Spring Hill Planning Commission Work Session

TO: Spring Hill Planning Commission
FROM: Gilles Morin, Senior Planner
MEETING: May 26, 2026
SUBJECT: PDF 2068-2026 (Project Blue)

Request: The applicant is requesting planned development final approval for a 2-story, approximately 184,239 square foot industrial manufacturing building that is a portion of the Spring Hill Commerce Center.

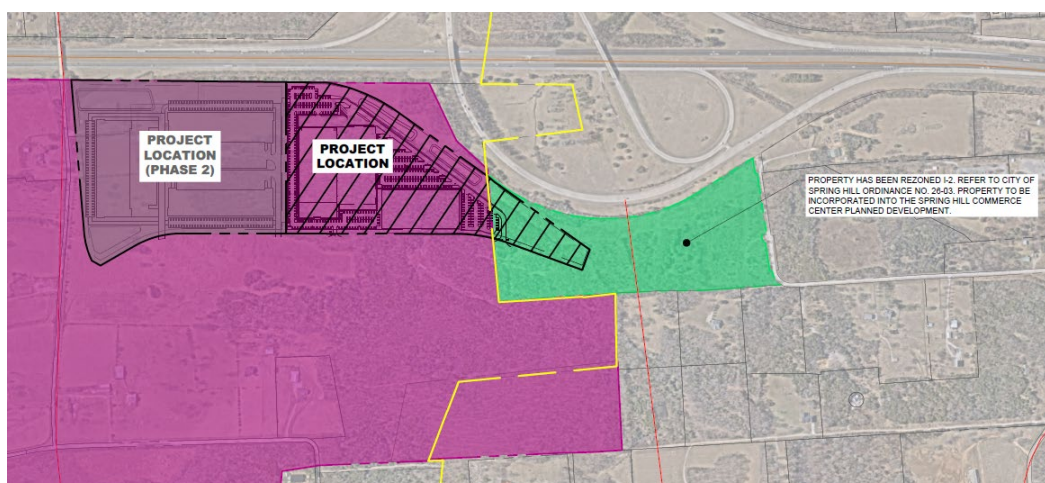
Ordinance 26-03 was approved on April 20, 2026, rezoning Williamson Tax Map 170, Parcel 009.00 from Agricultural to I-2 with the following condition of approval: The subject property is ineligible of development approval until it is incorporated into the Spring Hill Commerce Center Planned Development. See the green portion in the screenshot below that displays the area outside of the PD. Based on Ordinance 26-03, the area zoned I-2 should be removed from this request.
